Gainesville Renewable Energy Center Completeness Responses and Amendment to the Site Certification Application

Re: Gainesville Renewable Energy Center
Site Certification Application (PPSA No. PA09-55)
Completeness Responses and Amendment to the Site Certification Application

The completeness responses are provided in response to the Florida Department of Environmental Protection (FDEP) Determination that Application is Incomplete dated January 11, 2010. The responses provide additional information and clarifications to the requests from the reviewing agencies, which were included with FDEP's determination of incompleteness. For certain agency requests, GREC LLC clearly indicates the reasons why the requested information is not provided. Also, as indicated in several of the responses, GREC LLC has concluded that certain completeness items may be more suitably addressed through postcertification submittals and has recommended conditions of certification for several of these requests.

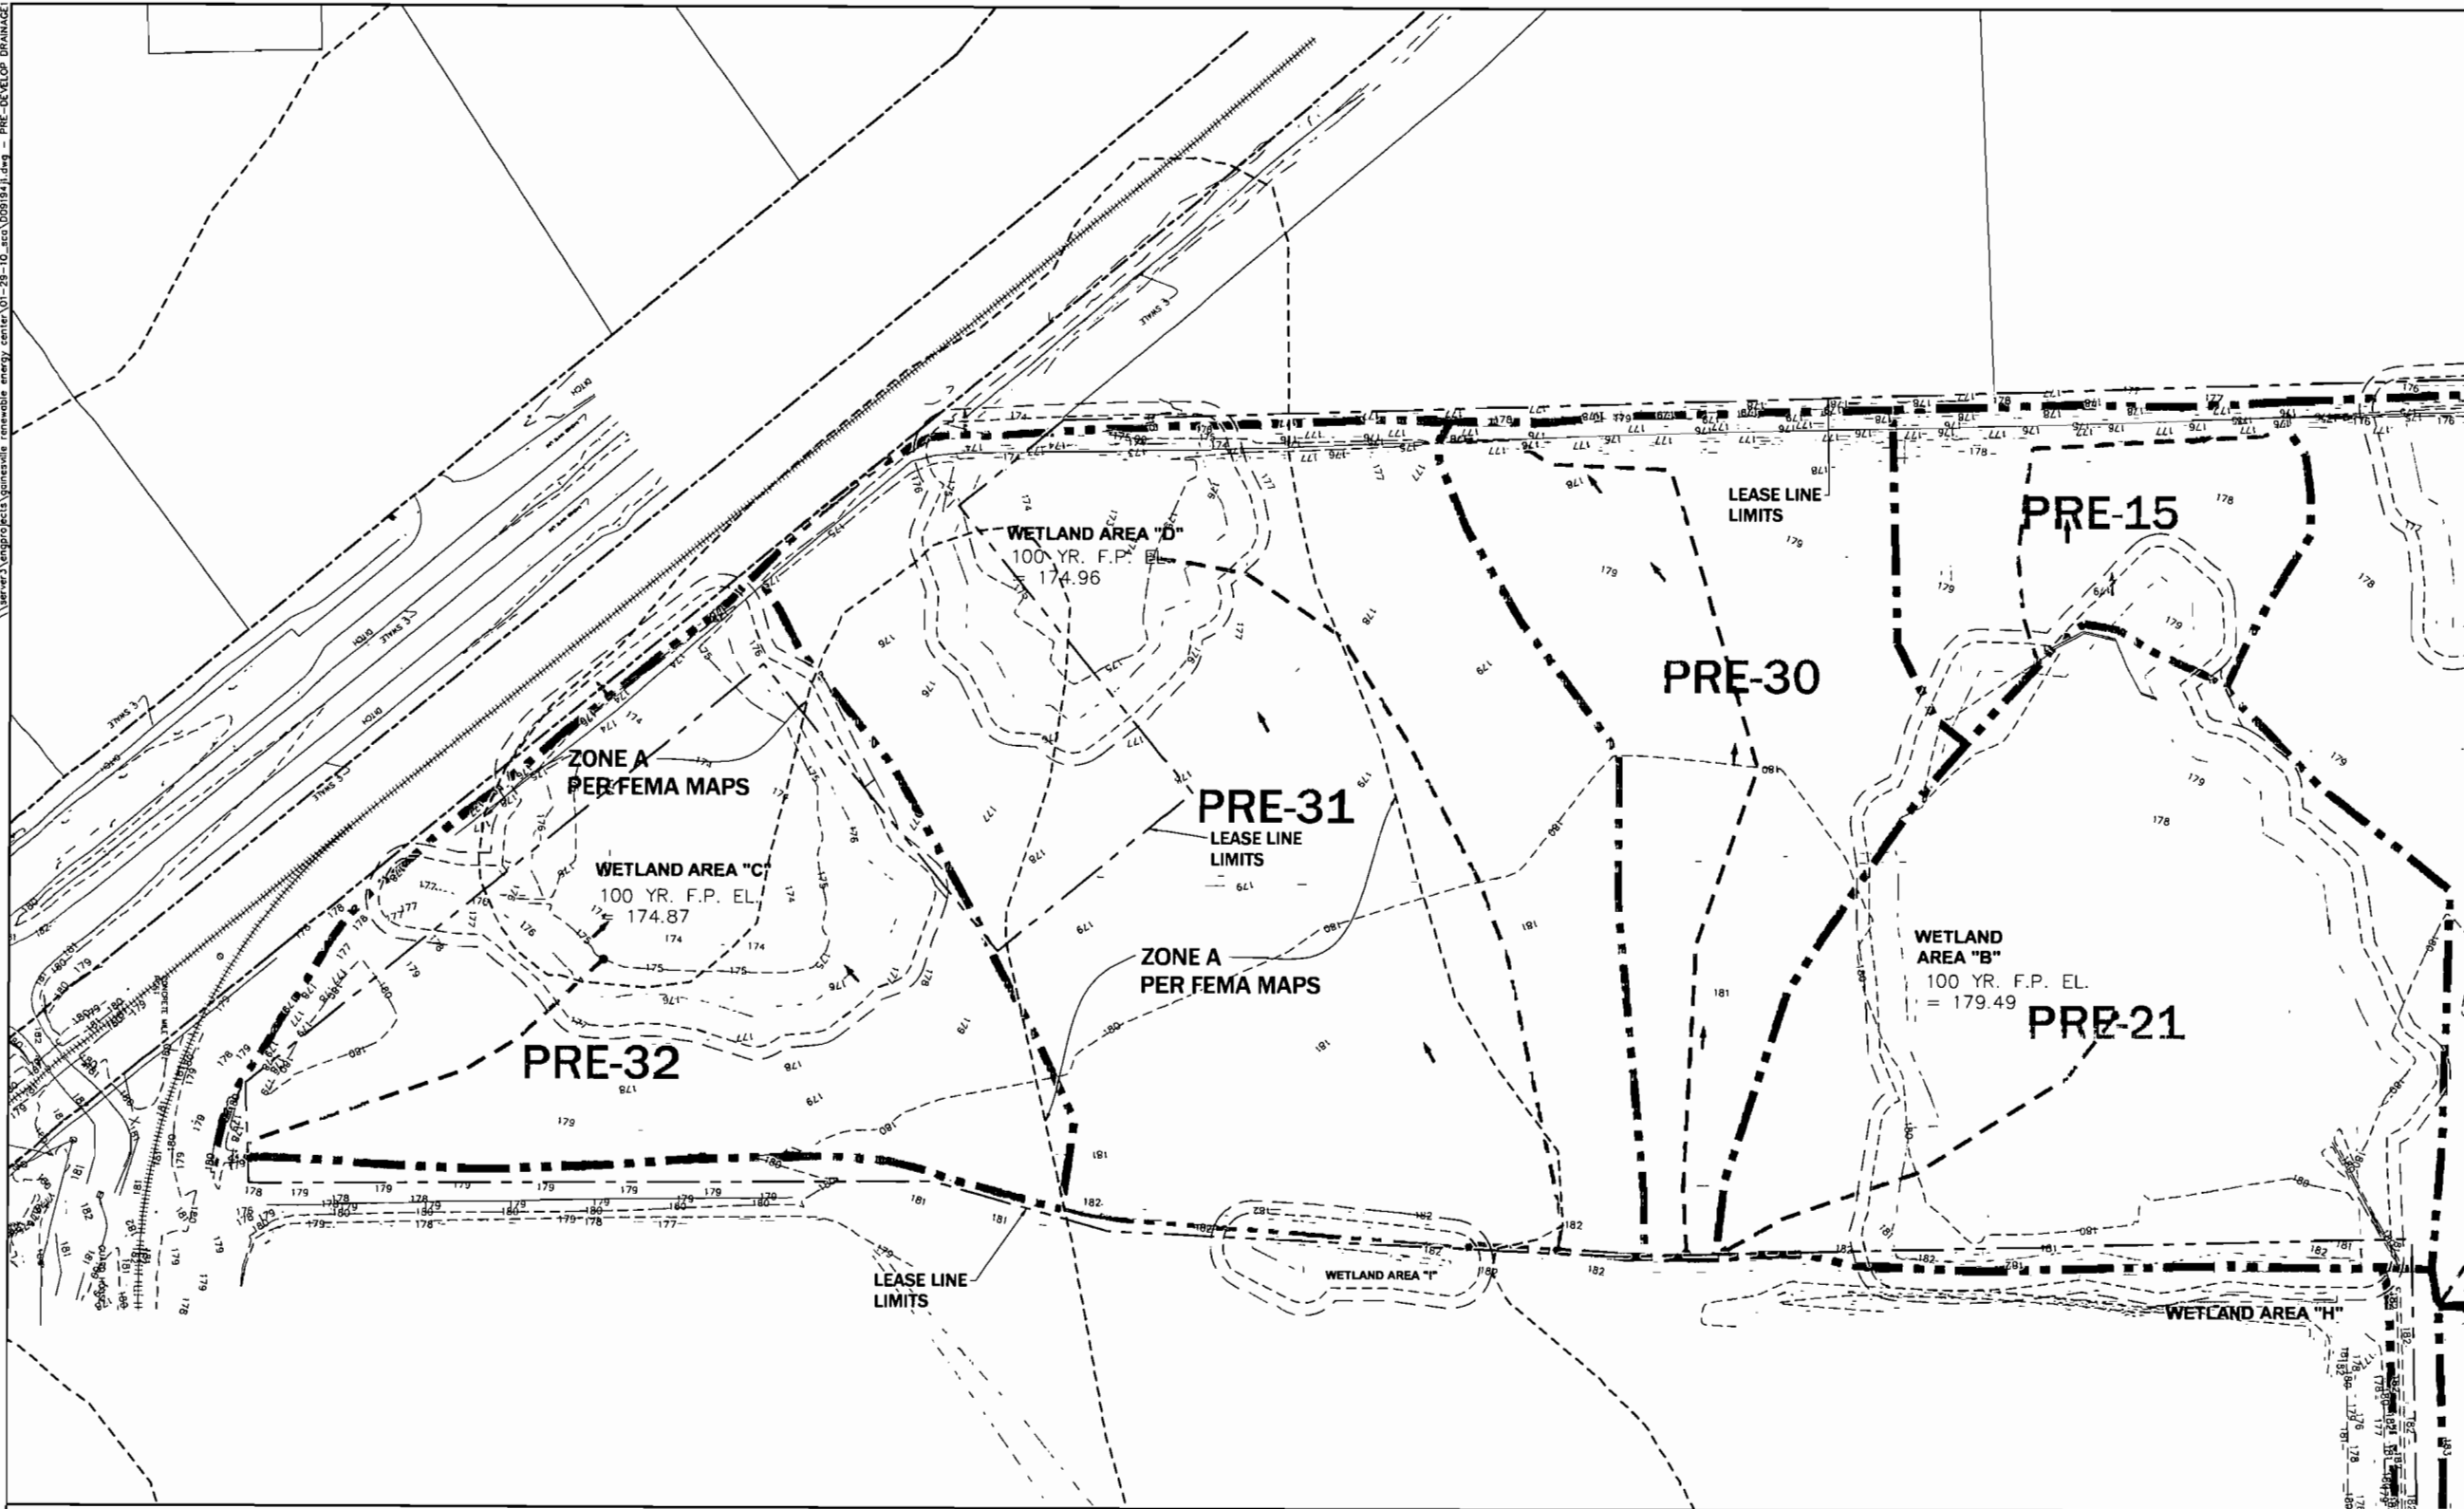
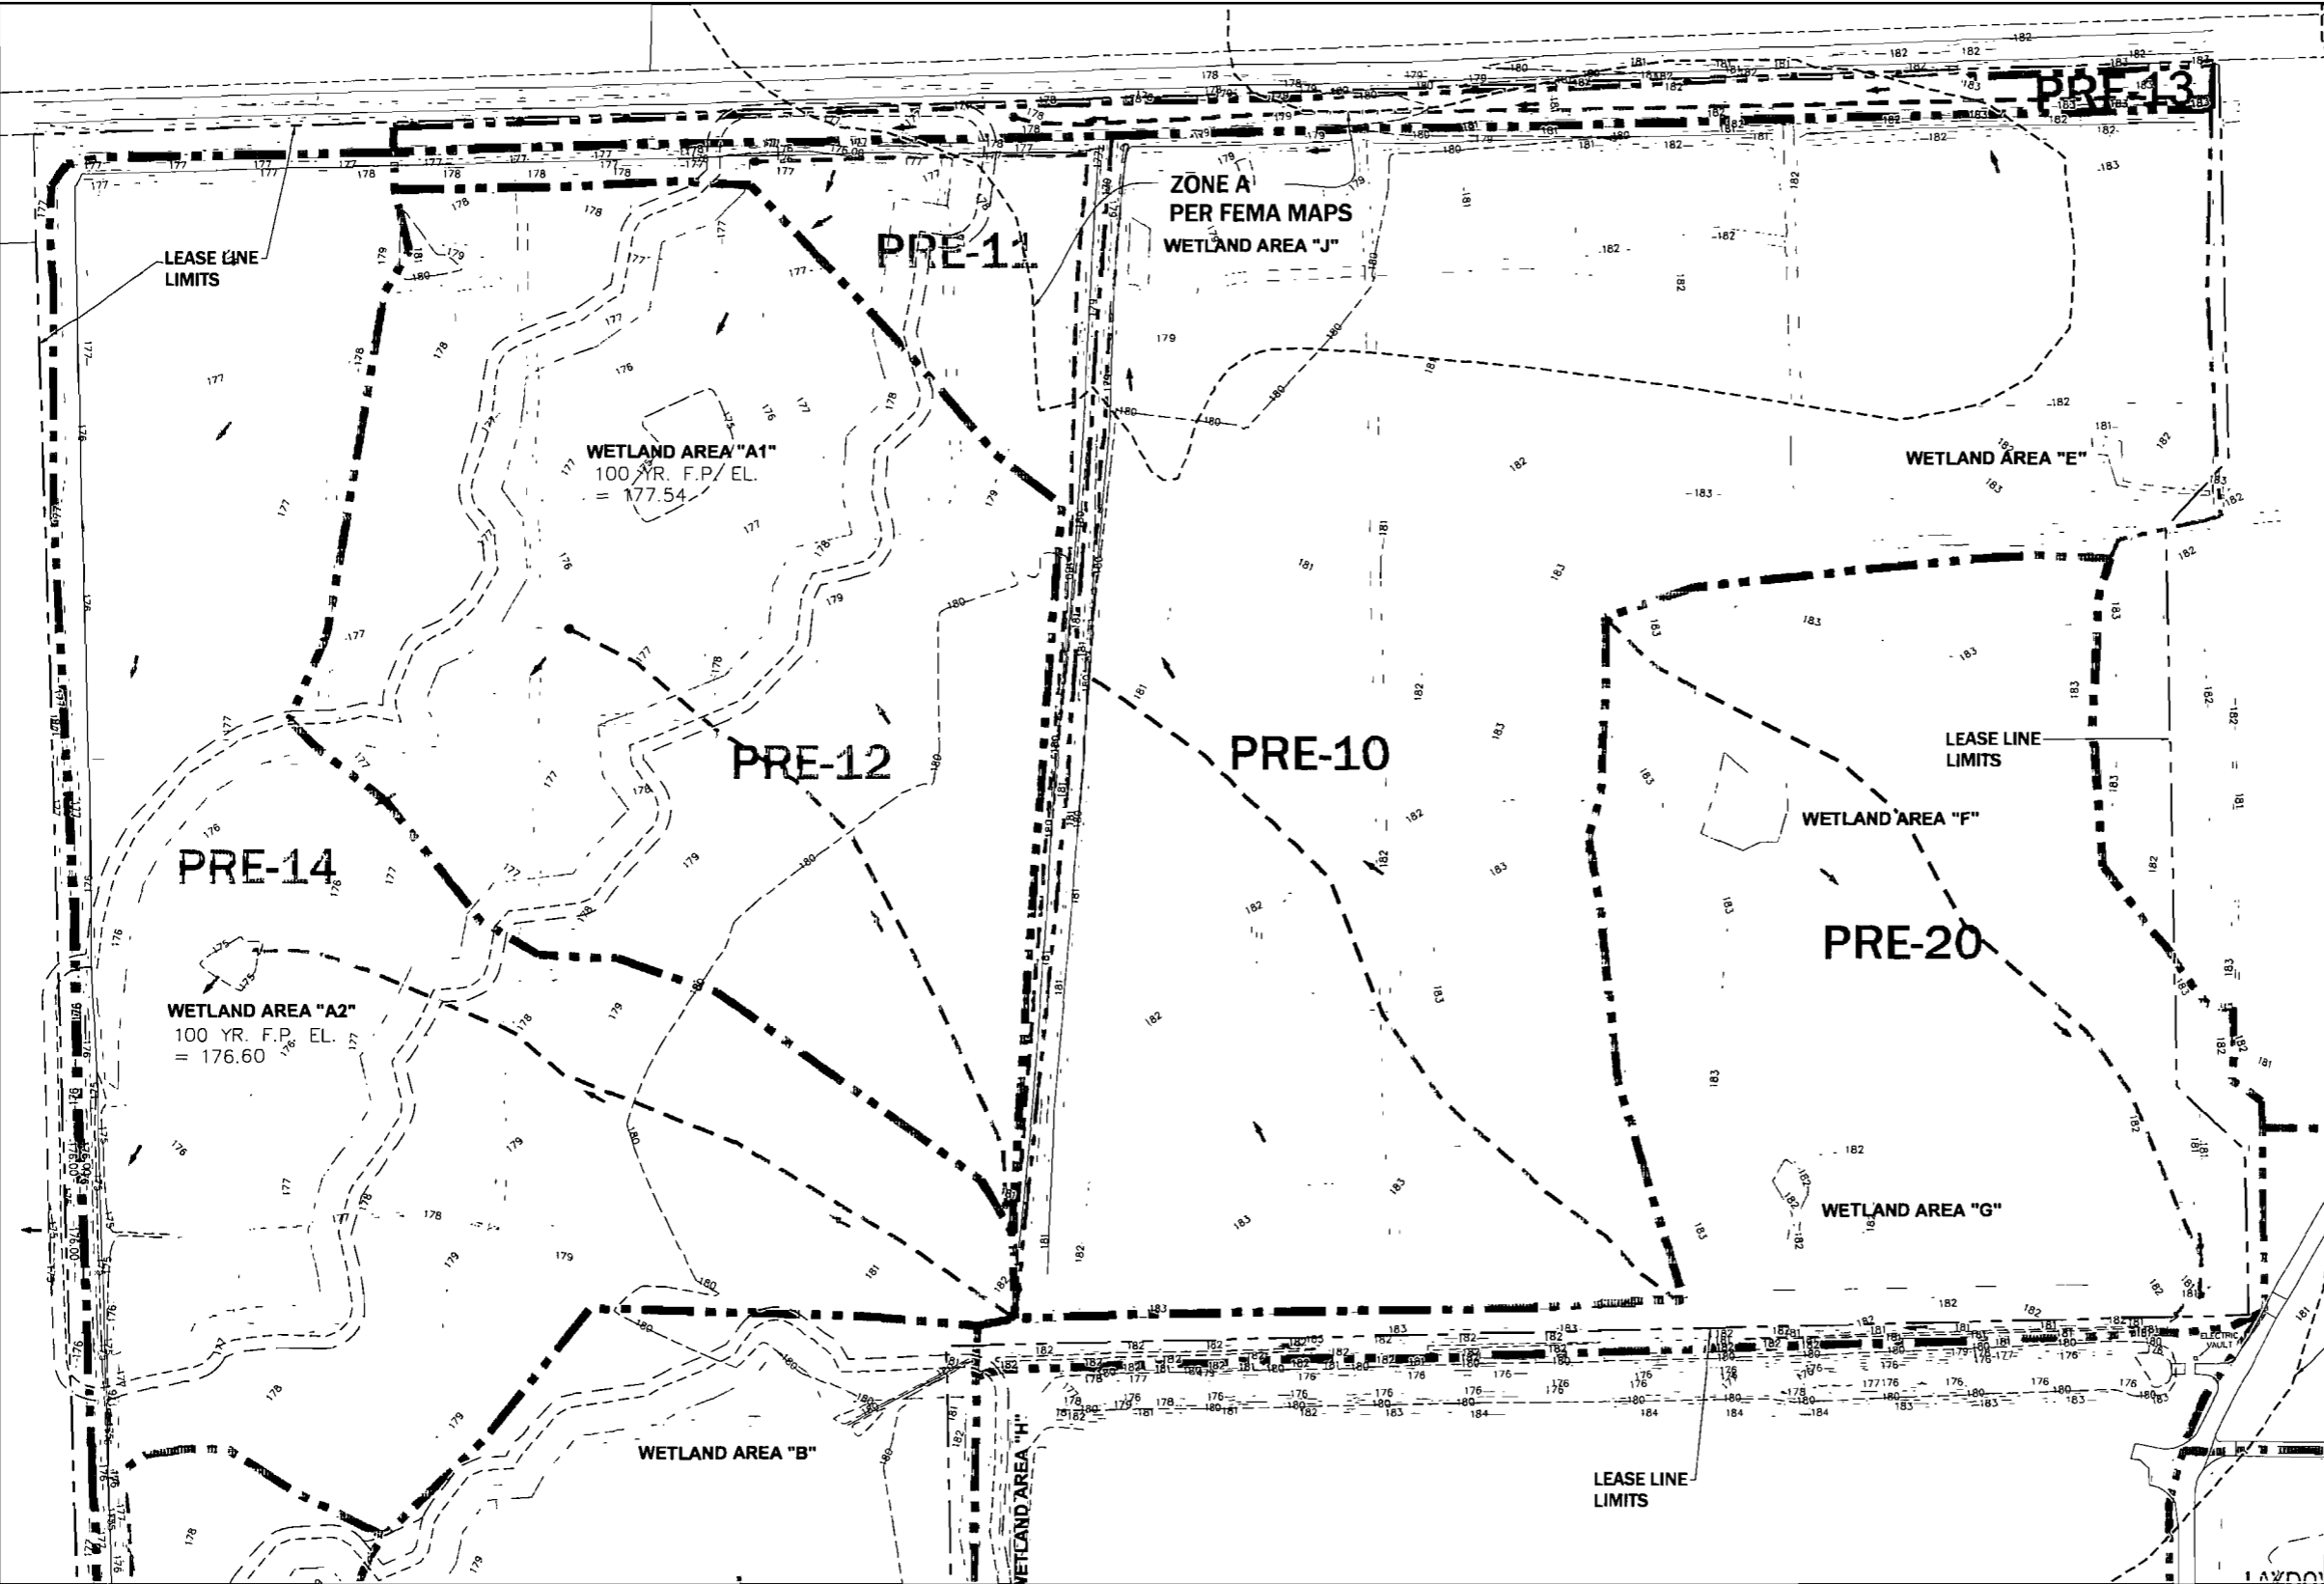
FDEPNEDSW-1 1) Contour lines in the Pre- and Post-development Drainage Maps, Sheets 1 and 2 of 2, found in Volume 2, Appendix 10.4.2, are labeled incorrectly. Please revise.

Referenced datum is North American vertical datum of 1988 (NAVD88) as shown in the notes in the boundary and topographic survey plan, sheet 1 of 5 in Attachment B to this document.

Conveyance of runoff into the proposed stormwater systems is shown in the grading plans (see sheets C2.20, C2.21, and C2.22 in Attachment B). These drawings are also included in the attached CD (stormwater management plan).
